AMENDMENTS TO THE DRAWINGS:

REMARKS

FIG. 4B

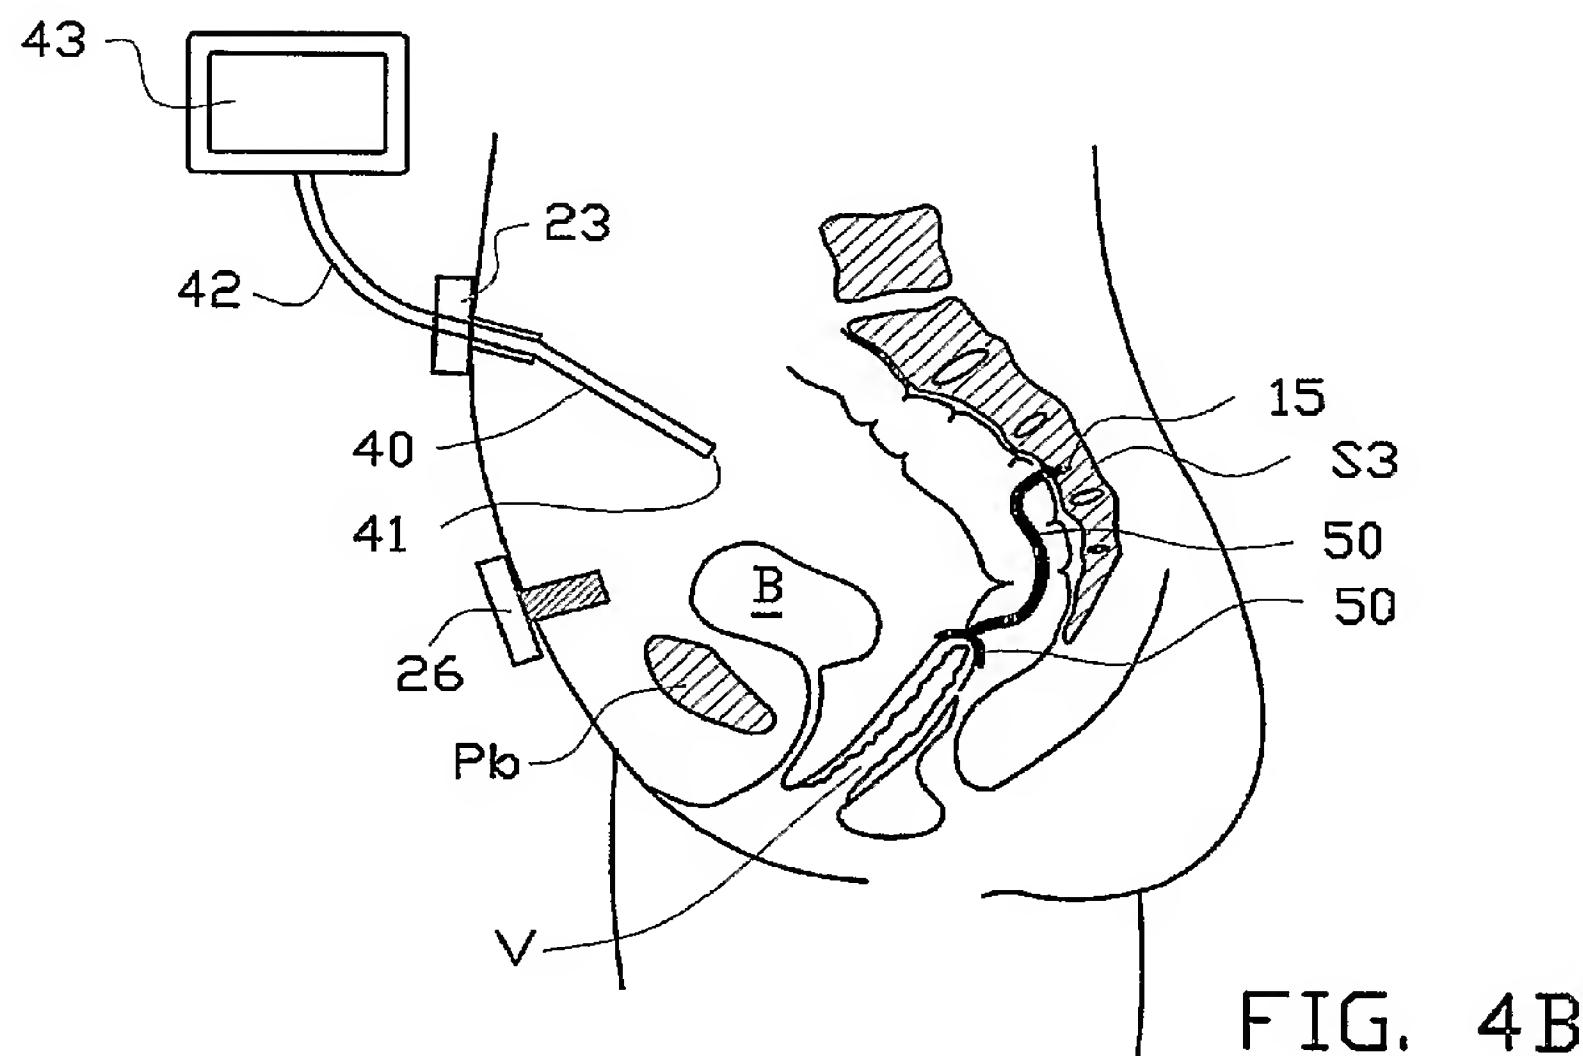
The drawings are objected to as not showing all the reference numerals discussed in the specification, and for showing reference numerals that are not discussed in the specification.

However, it is respectfully noted that in regards to the laparoscope 40, this feature has already been shown in Figure 4B (in conjunction with associated elements), which is reproduced below.

The drawing figures and the specification have been amended so that the reference numerals and the description correspond.

FIG. 22

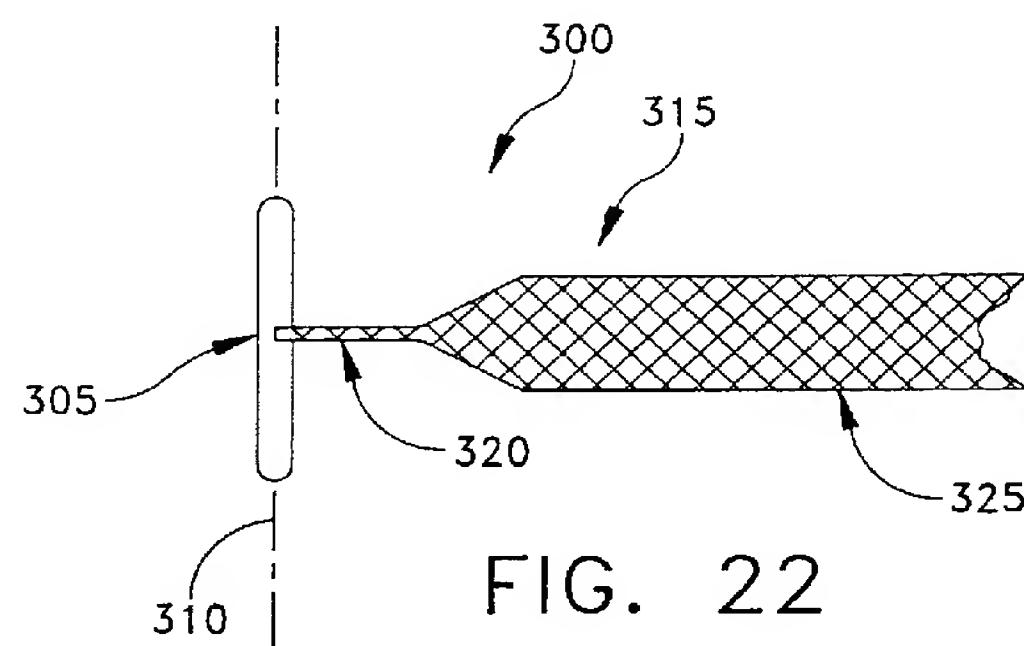
The Office Action refers to Figures 22 and 23 of LI, which are reproduced below.

Although in LI (Figures 22 and 23, and the corresponding description starting at column 15, line 66 to column 17, line 37) the suspension strap is partly situated within the housing 355, LI explicitly requires that at least the second portion 325 of the suspension strap 315 extends beyond the

housing 355 (as described, for example, at column 16, lines 58-62 and column 17, lines 12-17.

In contrast, the connection means (mat 50) of the present invention is wrapped around the second (inner) tube so that it can completely be positioned within the first (outer) tube, as is exemplarily shown in the enlargement of Figure 3C of the application, which is reproduced below.

In contrast, LI explicitly teaches that a part of the suspension strap has to project out of the housing, and thus teaches away from the present invention, in which the mat is completely situated within the outer tube. This difference is clearly set forth in the independent claims of the present invention. See also claims 116 and 118.
